Fuselage Section 13 — Forward — Door Surround Structure

Standardisation of the Fwd Cargo Door Surround Corner Fittings in Titanium Alloy

Object code	DMC-MRD-A-53-21-13-00A-040A-A	**Issue**	001-00 (new)
Issue date	2018-11-27	**Language**	en-GB
Responsible partner	AERALIS S.A.S. (U8025)	**Originator**	AERALIS S.A.S. — Design Office, Neuhafen (U8025)
Security	01 — Unclassified	**Quality assurance**	First verification (tabtop)
Applicability	MERIDIAN-42 and MERIDIAN-46, all aircraft

Fuselage Section 13 — Forward — Door Surround Structure — location, side view — Figure 1

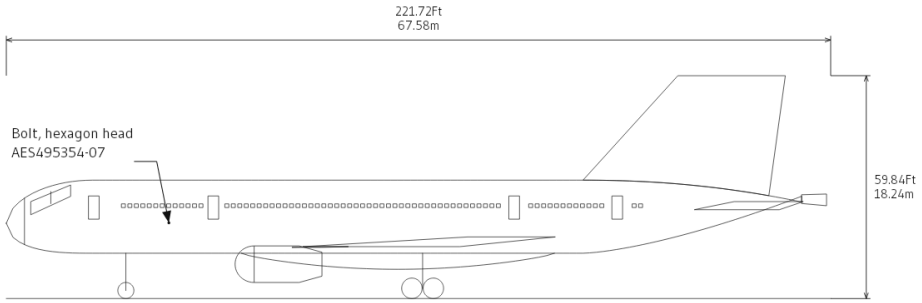
The four aluminium-lithium corner fittings of the forward cargo door cut-out are replaced by machined titanium items with a thicker flange and a larger load introduction radius, raising the fatigue allowable under the high-density freight spectrum.

Re-substantiation of the forward cargo door surround against the high-density freight loading spectrum introduced for combi and heavy-cargo operators showed a reserve factor shortfall at the lower corner fittings. Crack initiation was predicted between 34 000 and 42 000 flight cycles against a design service goal well above that. No in-service finding existed at launch; the change was driven entirely by the revised spectrum and by the fleet leader projection presented at the 2017 structures review.

The four aluminium-lithium fittings at the lower forward and lower aft corners of the cargo door cut-out are replaced by machined Ti-6Al-4V items of the same external envelope but with a 2.4 mm thicker attachment flange and a 9 mm fillet radius at the load introduction point. The web assembly D5321003375416 is retained and is re-drilled locally to the new pattern; the joint is closed with titanium bolts AES495354-07 and countersunk washers AES963502K7 in place of

the previous protruding-head set. Revised detail is carried on drawings D53211308437 and D53211167819. Access is through the forward cargo compartment in zones 113 and 115, with the lower shell lining removed locally.
